DISTRICT	COUNTY	ROUTE	SECTION	SHEET
6-0	MONTGOMERY	0000	LKT	6 OF 29
LIMERICK TOWNSHIP				
REVISION NUMBER	REVISIONS			DATE
				BY

TYPICAL SECTIONS

N LEWIS ROAD (SR 4022)
STA 306+75.17 TO STA 311+00.00
TYPICAL SECTION

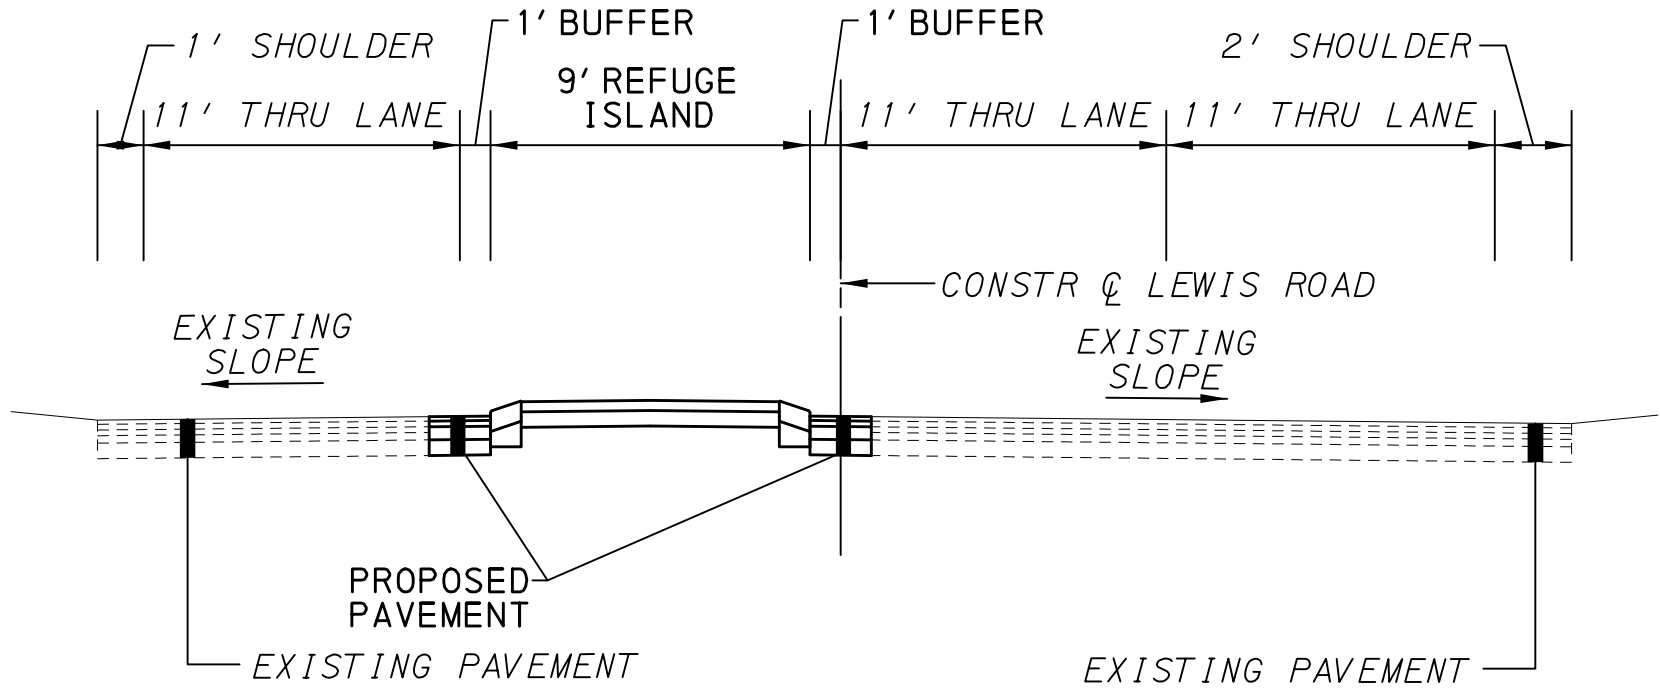
CAN THIS SLOPE TIE IN
CRITERIA BE ENTERED
IN CORRIDORS USING
ONE OF THE
INSTRUCTION TYPES?
MAYBE CONDITIONAL?
I WILL HAVE AN
EXISTING SURFACE
THIS WEEK TO USE
FOR A TARGET
SURFACE.
